Site Survey of Selected Items
for
Compliance with the Americans with Disabilities Act
(ADAAG)
and
Title 24 of the CBC

The site survey of Walgrove Elementary School was conducted on February 28, 2007 during a spot check for compliance with the Americans with Disabilities Act Guidelines (ADAAG) and Title 24 of the CBC

Facility Name: Walgrove Elementary School

Accessible Parking

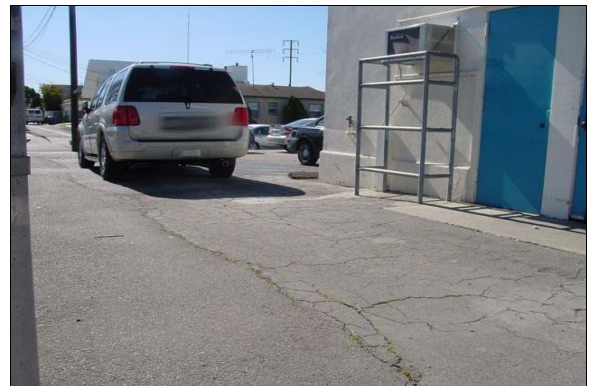
Finding: The parking signage at the standard accessible space contains the word "Handicapped."

Full Rec Install a permanently posted reflectorized sign measuring 70 square inches that includes an ISA symbol adjacent to and visible from the accessible parking space (see CBC 1129B.5). The bottom edge of the sign must be mounted 80 inches from the ground surface so that it cannot be obscured by a parked vehicle (see CBC 1129B.5). Signage shall not contain the word "Handicapped."

Boys Restroom Building A

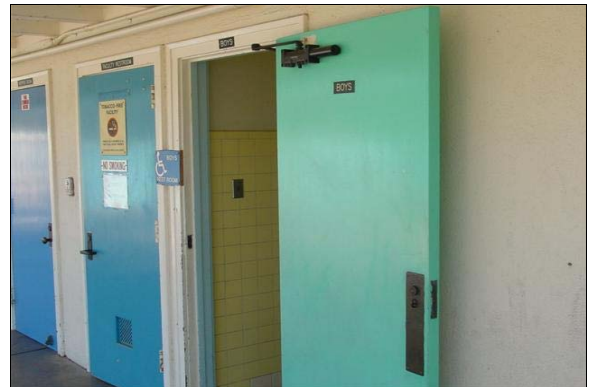
Finding: There is signage posted on the latch side of the entry door to the restroom. The signage does not include the gender use symbol. There is accessible signage posted on the entry door to the restroom.

Full Rec Post signage centered 60 inches above the ground surface on the latch side of the entrance door identifying the restroom as accessible. Signage shall include Braille and raised lettering, the gender or unisex use symbol and the ISA symbol.

Boys Restroom Building A

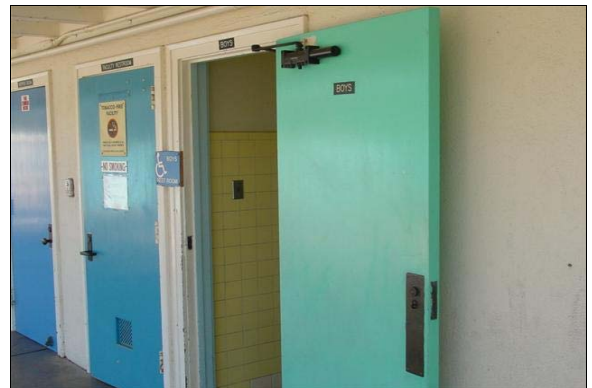
Finding: The bottom 10 inches of the door does not provide a smooth, uninterrupted surface, or panel to allow the door to be opened by a wheelchair footrest without creating a trap or hazardous condition, due to a doorstop.

Full Rec Remove the doorstop from the door to provide a smooth, uninterrupted surface for the bottom 10 inches of the door.

Girls Restroom Building A

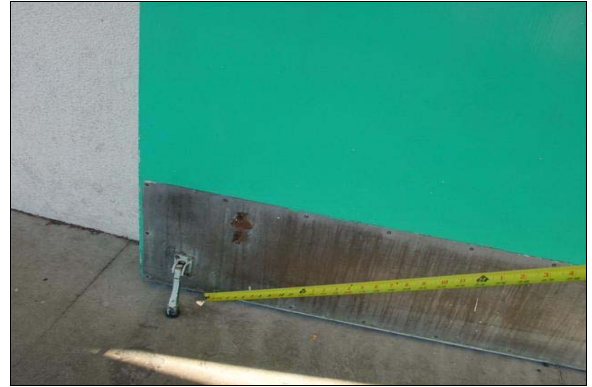
Finding: There is no signage indicating accessibility on the latch side of the entry door of the restroom. There is Title 24 gender use signage on the entrance door.

Full Rec Post signage centered 60 inches above the ground surface on the latch side of the entrance door identifying the restroom as accessible. Signage shall include Braille and raised lettering, the gender or unisex use symbol and the ISA symbol.

Girls Restroom Building A

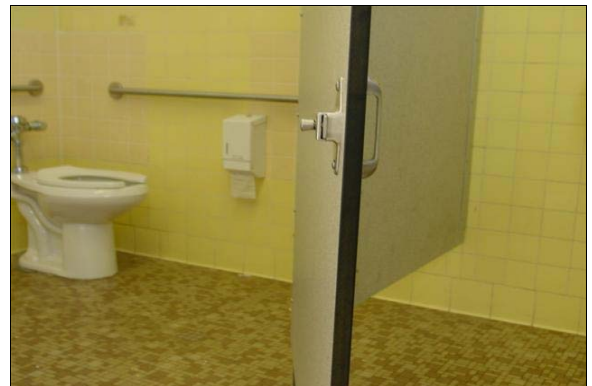
Finding: There is insufficient clear floor space provided in front of the water closet. The door to the stall designated to be accessible in the restroom does not have accessible hardware.

Full Rec Modify or replace the stall designated to be accessible in the restroom so that it complies with ADAAG 4.17.3, CBC 1115B and CBC Figures 11B-1A and 1B. Standard accessible stalls require 60 inches in width with 56 inches depth for wall-mounted toilets or 59 inches depth for floor-mounted toilets to accommodate individuals in wheelchairs. The minimum width of a front-approach doorway shall provide at least 32 inches and a side-approach doorway shall provide at least 34 inches. The door shall swing outward, close automatically and provide accessible hardware.
